Subject: Duke Energy Carolinas, LLC
Oconee Nuclear Station
Renewed Facility Operating Licenses Numbers DPR-38, DPR-47, and DPR-55;
Docket Numbers 50-269, 50-270, and 50-287
Responses to Request for Additional Information for the License Amendment
Request to Revise Portions of the Updated Final Safety Analysis Report Related to
the Tornado Licensing Basis; License Amendment Request: 2006-009

Duke Responses to RAI

DUKE POWER COMPANY
OCONEE NUCLEAR STATION UNIT 1
ONE LINE DIAGRAM
6900V & 4160V STA AUXILIARY CYS

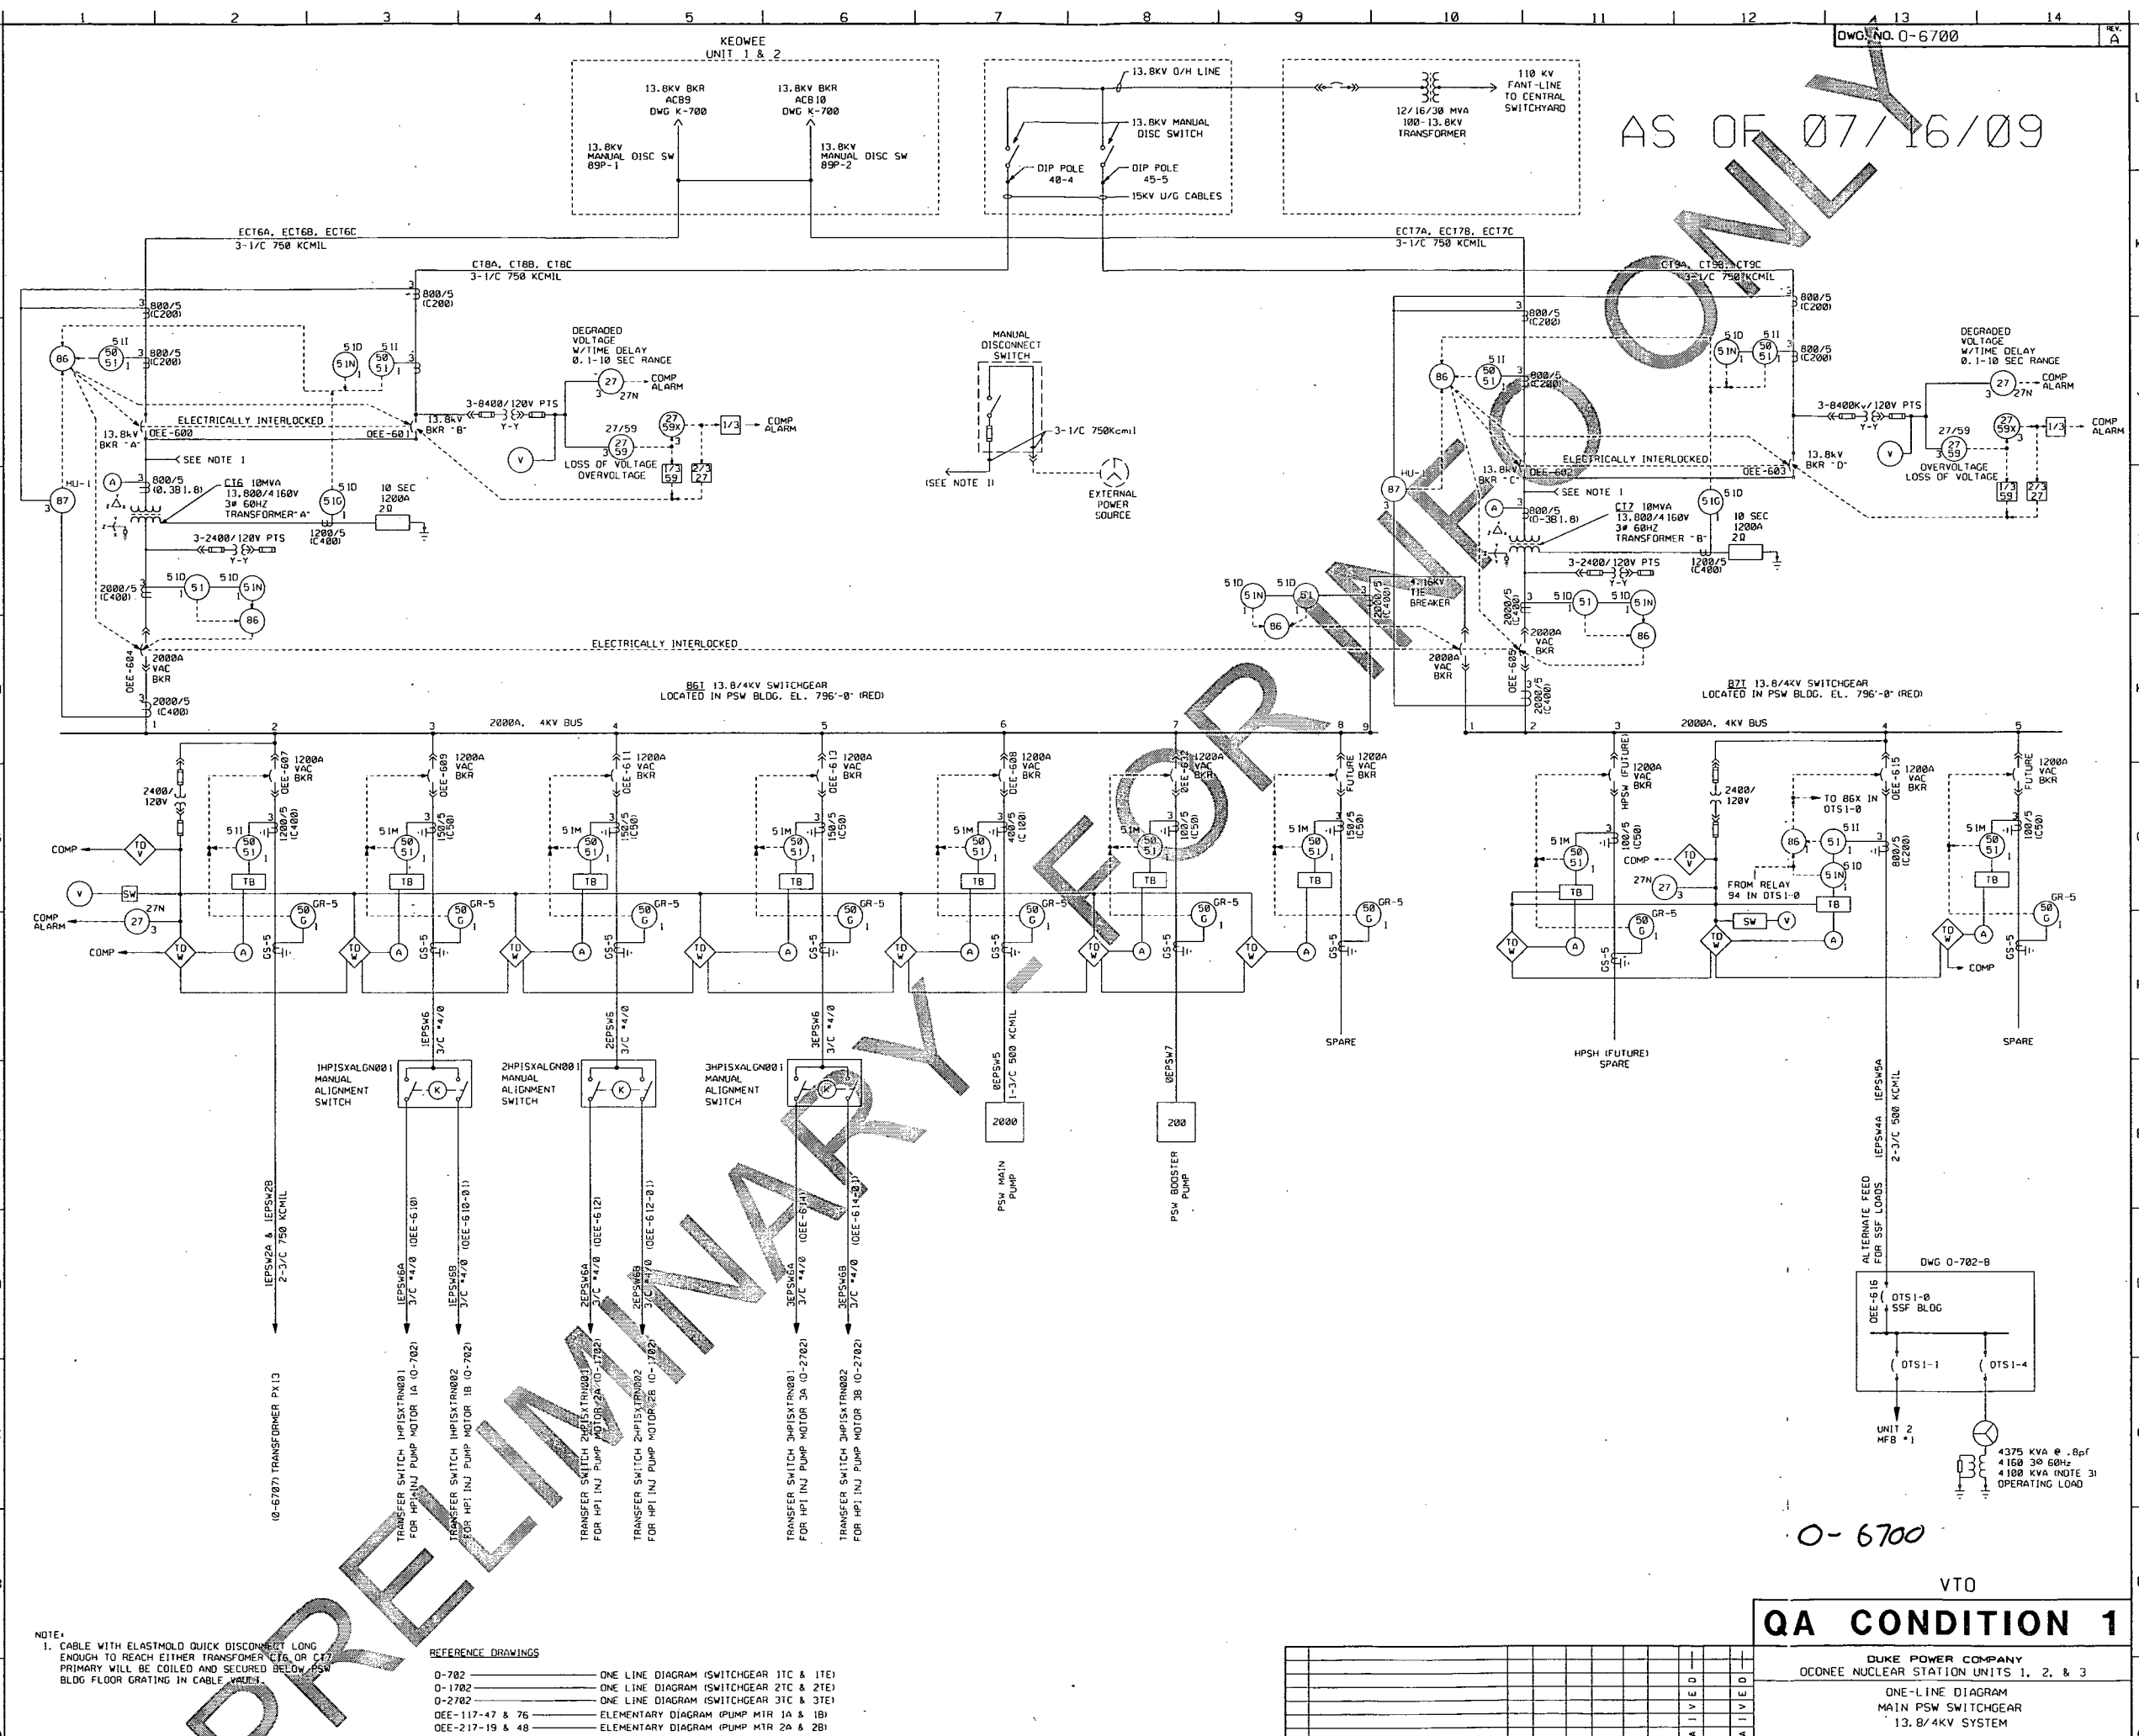
Provide the following information for the new protected service water (PSW) transformer, switchgear, load center and the circuit breakers: 1) equipment design ratings, 2) a summary of the analyses performed to show the loading, short circuit values and the interrupting ratings, voltage drop, and protection and coordination, 3) the existing station auxiliary service water (ASW) switchgear ratings, and 4) the periodic inspection and testing requirements for electrical equipment. Provide applicable schematic and single line diagrams.

3. The existing station Auxiliary Service Water (ASW) switchgear breaker ratings are four (4) 1200A breakers, and four (4) 600A breakers (Ref. dwg O-702-A1).

- O-702-A1 – One Line Diagram 6900V & 4160V Station Auxiliary System

DUKE POWER COMPANY
OCONEE NUCLEAR STATION UNIT 1
ONE-LINE DIAGRAM
STATION AUXILIARY CIRCUITS 600V
MCC 1XPSW

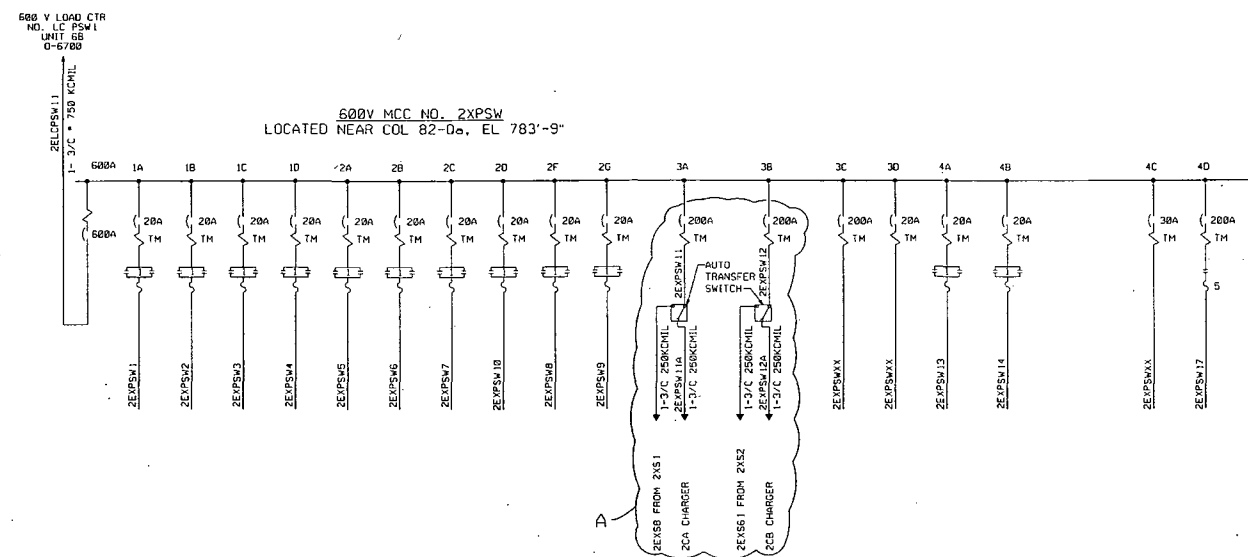
Provide the following information concerning the proposed PSW instrumentation and control (I&C) power and the interface with the existing plant vital I&C power: 1) design of the DC

Applicable schematics and single line diagrams are: O-6700-01, O-6701, O-6702, and O-6703.
